ISSUE: Permit to Demolish/Capsulate (partial) and Certificate of Appropriateness for alterations

APPLICANT: Sean and Jill Milliken, represented by Karen Conkey, Architect

LOCATION: Old and Historic Alexandria District or Parker-Gray District
101 Queen Street

BAR#2024-00347 & BAR#2024-00348
101 Queen Street

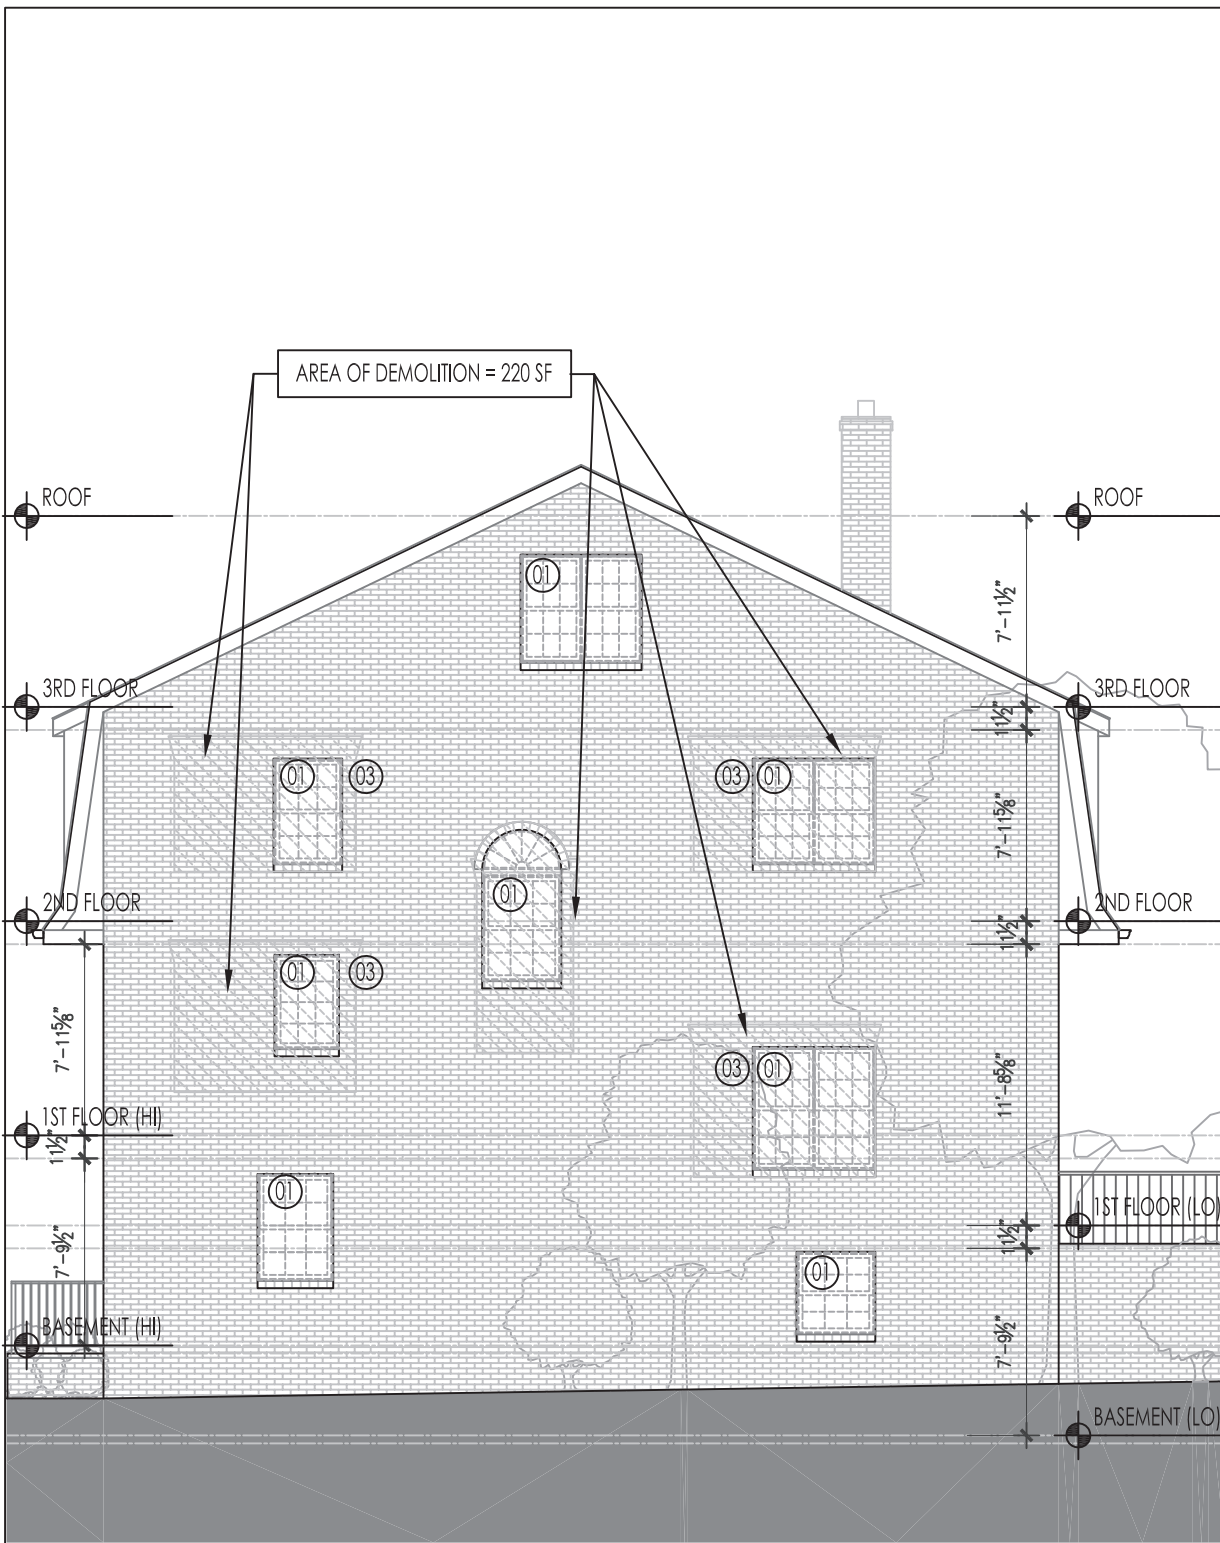
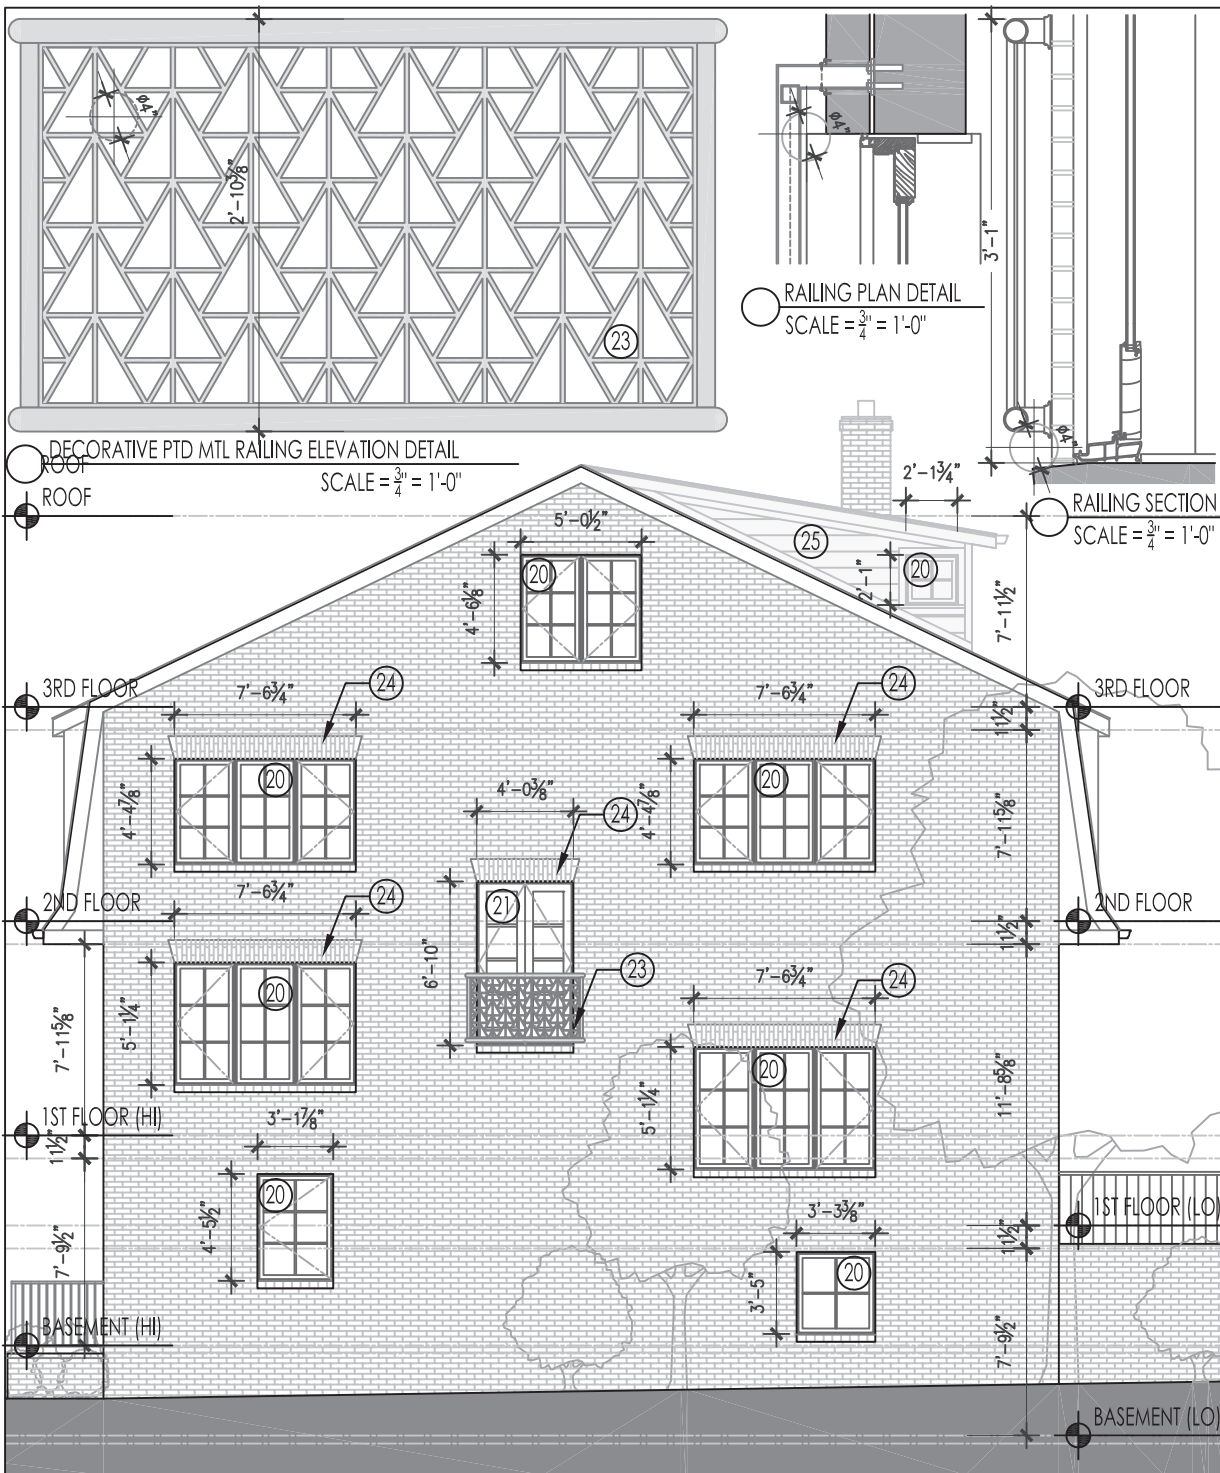
The applicant is requesting approval to demolish approximately 242.19 ft² of existing masonry wall area on the east (side) elevation and north (rear) elevation to enlarge four windows.

In the opinion of staff, none of the criteria for demolition and capsulation are met and the Permit to Demolish/Capsulate should be granted. The areas to be demolished are not historic and the materials are not of unusual or uncommon design and could be reproduced easily. Furthermore, the demolition does not remove any portion of the building containing character defining features of uncommon design or historic merit and does not compromise the integrity of the building as a whole. Therefore, staff supports the application for a Permit to Demolish/Capsulate, as submitted.

The BAR’s *Design Guidelines* state that “windows and doors are character defining features of buildings that can greatly impact the style and aesthetic of a structure.” In this case, the proposed enlargement and replacement of the existing windows will not have a negative impact on the historic fabric of this later building. The current design of the townhouse lacks any historic significance or architectural distinction.

Likewise, the Board has continuously approved similar projects of window enlargement and dormer installation on buildings that face or have an elevation facing North Union Street, as homeowners wish to maximize the view of the Founder’s Park and the Potomac River. In addition, the Board approved a similar project at 100 Quay Street, the subject building’s rear neighbor, on March 5, 2014, BAR2014-00032 & BAR 2014-00033 (Figure 3). This townhouse was already painted when the project came before the Board for window enlargement in 2014.

PROPOSED REAR ELEVATION

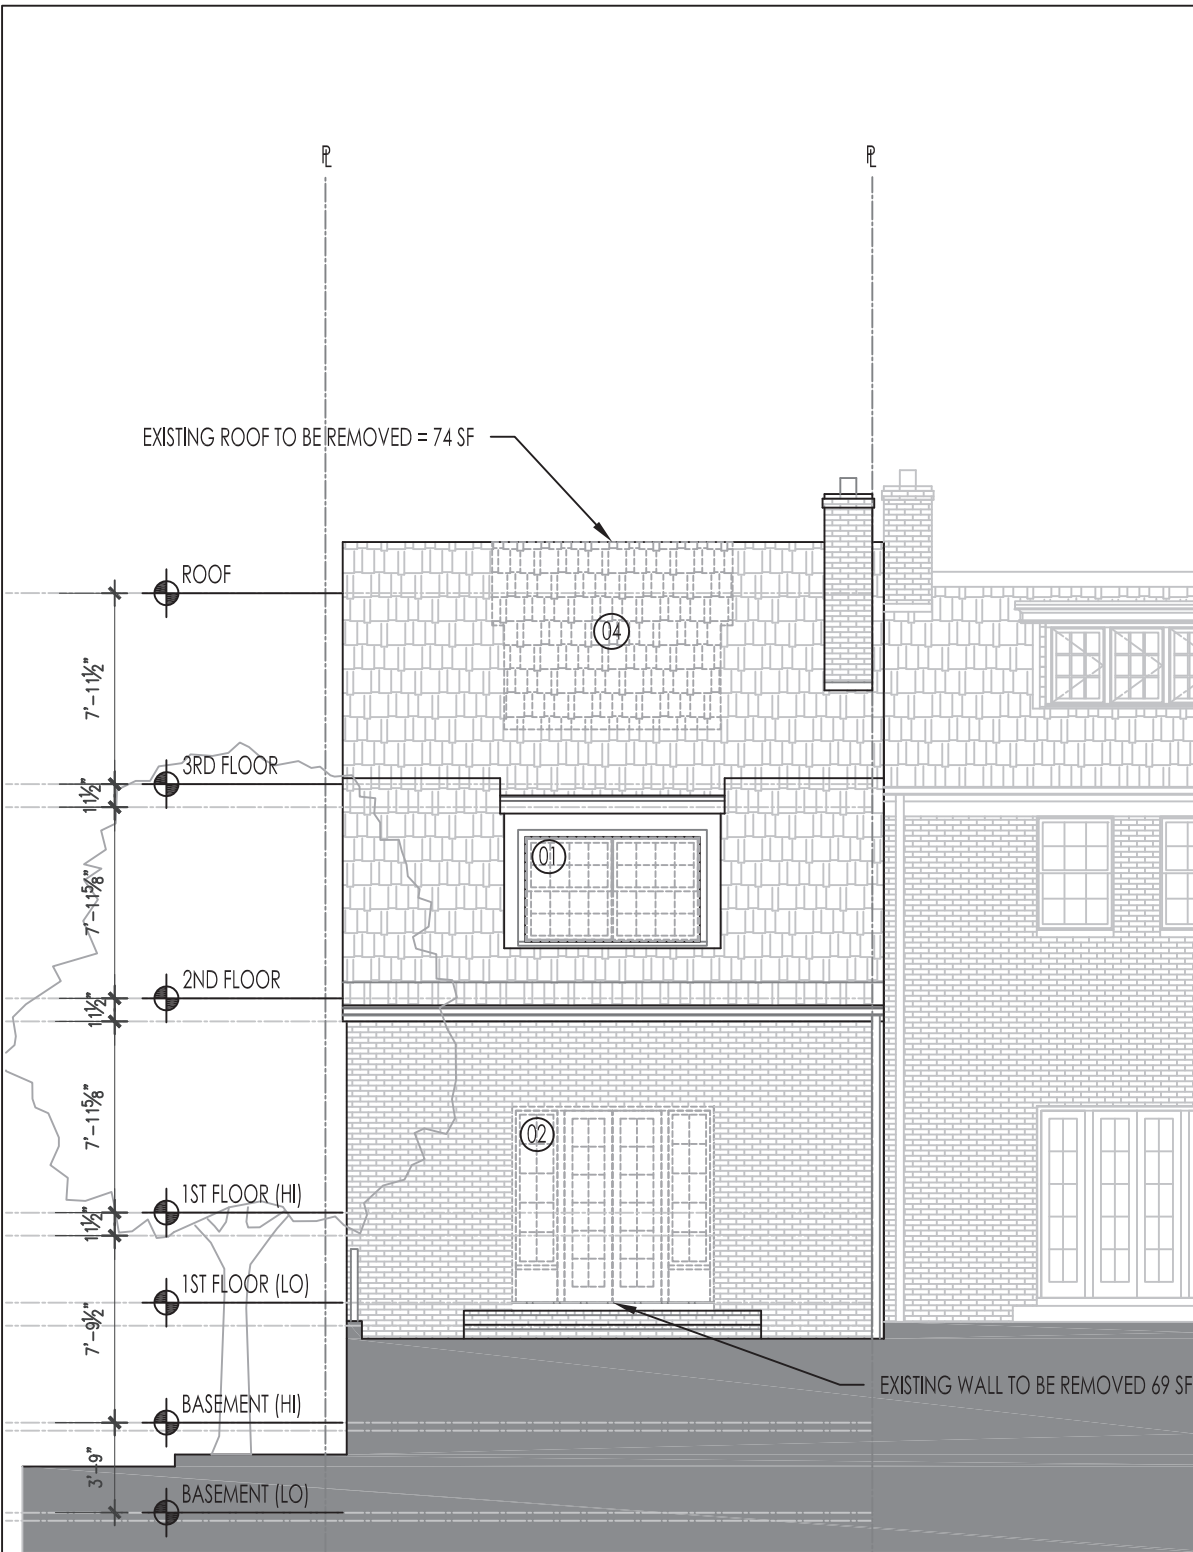
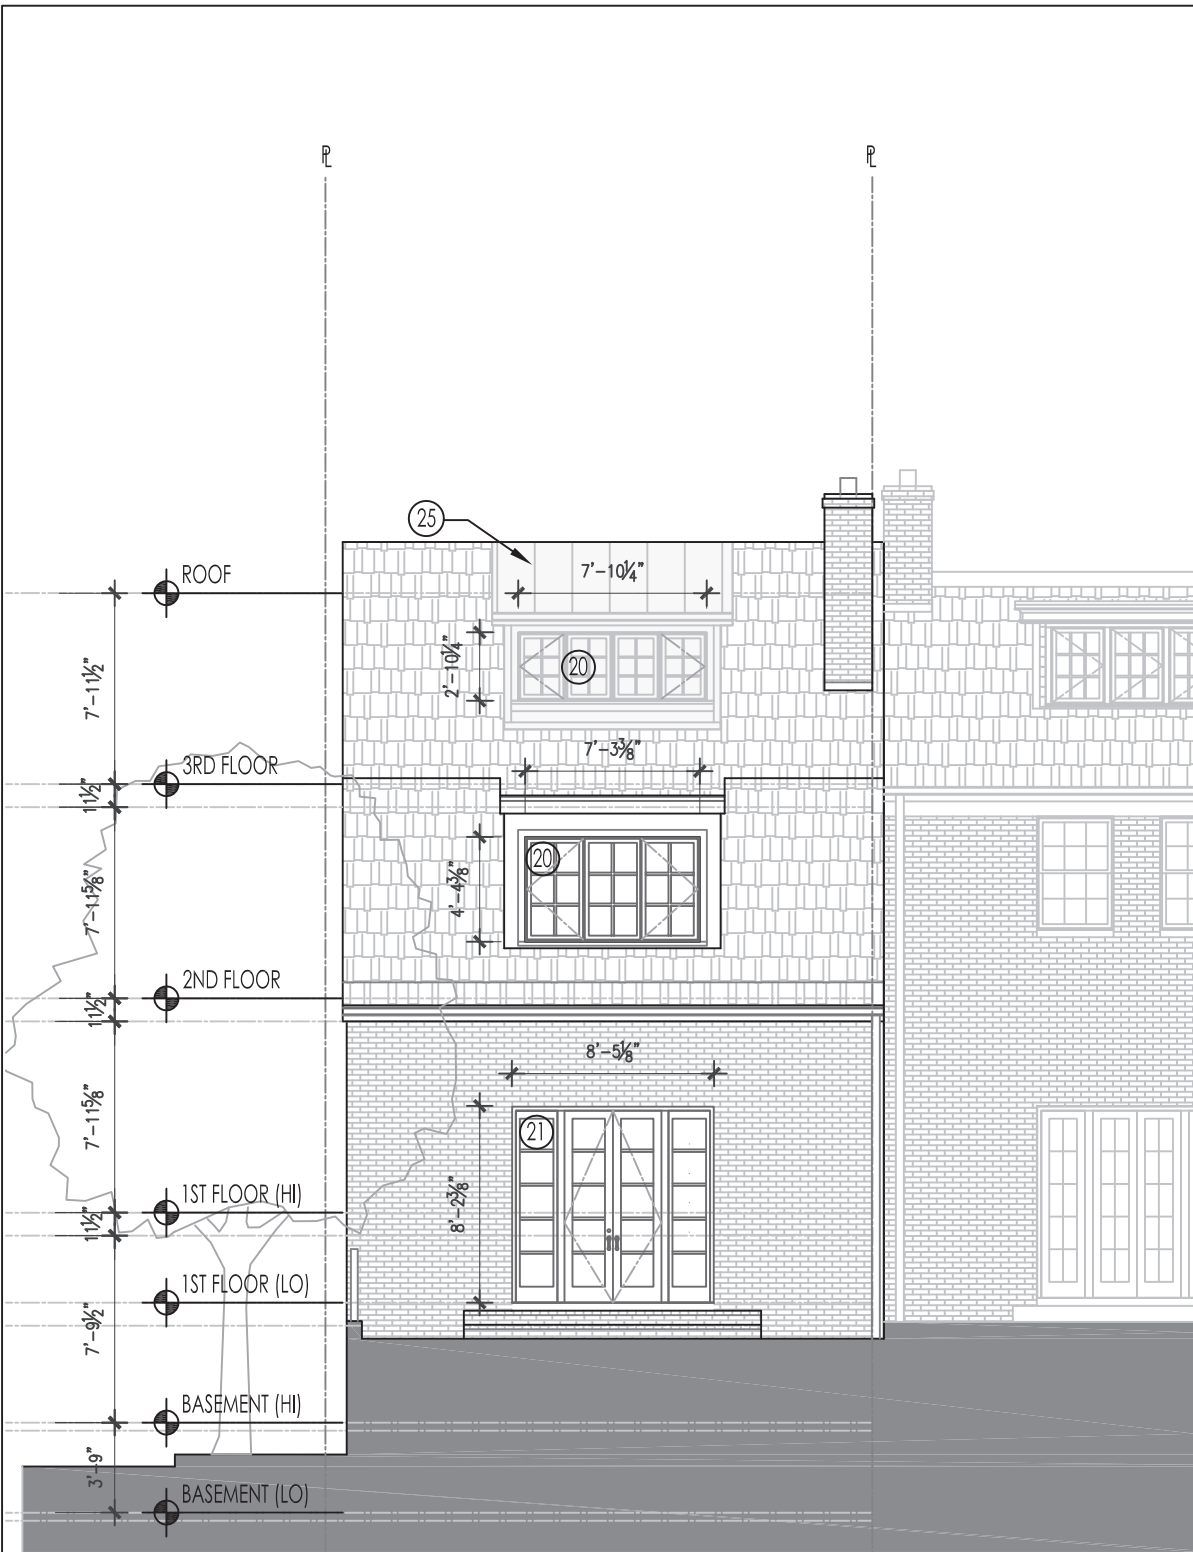
The project also proposes to construct a 22.29 ft² shed dormer on the rear elevation and to replace all existing windows with aluminum-clad, casement windows with six-light grids. The rear French door with sidelights is also being replaced with the same material and light configuration. Additionally, the applicant is proposing to stain the unpainted masonry building.

The *Design Guidelines* states that dormers provide light and ventilation to the top floor of a building and can increase the usable floor area. Dormers are also visible elements of a roof and can have adverse impacts on a building if not properly designed. The proposed dormer is appropriate to the architectural style of the existing building and all the windows are operable and in the same style as the rest of the proposed replacement windows. No historic fabric will be lost from the installation of the dormer and staff has no objection to its construction.
